**Project**      **IEEE 802.16 Broadband Wireless Access Working Group** <<http://ieee802.org/16>>

**Title**          **SA-TEK Procedure Optimization during HO**

**Data**          **2005-07-14**

**Re:**             IEEE P802.16e/D9

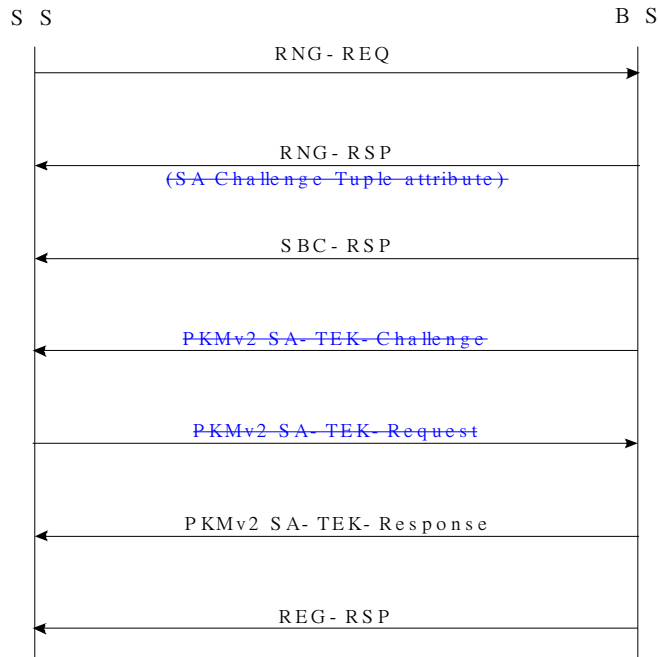
In case of omitting the authorization procedure, it is more reasonable that a target BS transmits negotiated cryptographic suite, updated SAIDs, and updated TEK through a PKMv2 SA-TEK-Response message to an MS than exchanging 3-way SA-TEK-related messages. Therefore, a PKMv2 SA-TEK-Request message and a PKMv2 SA-TEK-Response message are unnecessary during HO. The SA-Challenge tuple attribute included in the RNG-RSP message is also unnecessary.

In addition, the function and attributes of a PKMv2 SA-TEK-Response message are duplicated with those of SA TEK Update field included in the REG-RSP message.

The following figure shows the flow diagram, in case of optimizing Handover process (i.e., the case of omitting SBC-REQ, REG-REQ, and authorization procedure.) It is more efficient to skip PKMv2 SA-TEK-Challenge and PKMv2 SA-TEK-Request messages and to use only PKMv2 SA-TEK-Response message.

Only in case of omitting the authorization procedure, it is more reasonable that a target BS transmits negotiated cryptographic suite, updated SAIDs, and updated TEK through a PKMv2 SA-TEK-Response message to an MS. Therefore, a PKMv2 SA-TEK-Request message and a PKMv2 SA-TEK-Response message are unnecessary during HO. The SA-Challenge tuple attribute

In addition, since the function and attributes in a PKMv2 SA-TEK-Response message are duplicated with those of SA TEK Update field included in the REG-RSP message, the SA TEK Update attribute is not necessary.
